RE: Stevensville Schools HS Main Gym Roof Replacement – Public Bid

ADDENDUM #1

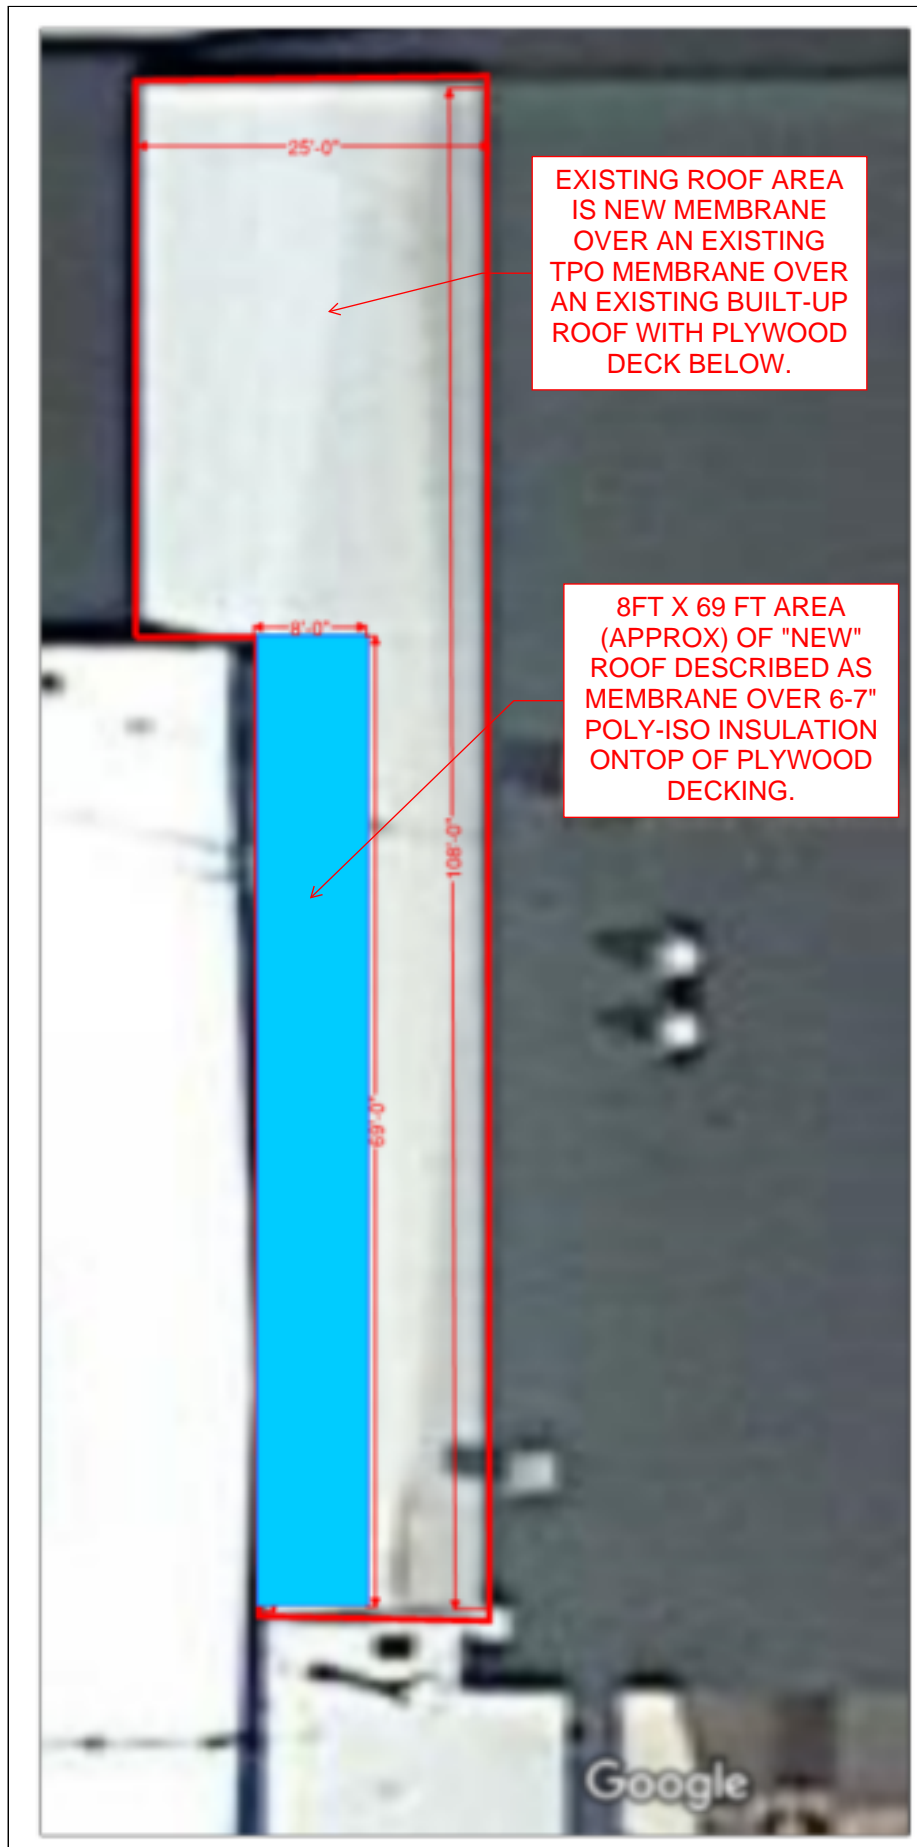
- A. At the pre-bid walkthrough, potential bidder and Stevensville School representatives investigated the membrane roof assembly further and discovered there are two roof assemblies. (See Exhibit 1A included herein) The work to re-roof the membrane flat roof is described in Bid Alternate #2 and is modified as follows:

- a. Include demo of only the top most layer of membrane for the roof area identified in the bid documents.
 - b. Do not disturb the layers beneath as the old roof bottom layers are assumed to be ACM.

- c. Cut the existing membrane about 18” above roof surface on the building wall, lap new membrane behind existing membrane and term-bar and caulk.
 - d. On the bulkhead wall to the south edge of work area, wrap new membrane up and over wall and term-bar on backside of bulkhead wall. Re-flash scupper passthrough opening as necessary.

- e. At the two existing roof drains, demo existing drain retrofit kits and drain covers and furnish and install new with the new membrane roof assembly.

- f. Include longer screws for the area of “new” roof assembly where there is 6-8” poly-iso insulation.
 - g. There is an existing poly-iso ridge that exists that was hand-shaved at about a 45-degree angle. Include hand shaving (tapering) this existing insulation to a further reduced angle to eliminate the sharp ridge under the membrane.
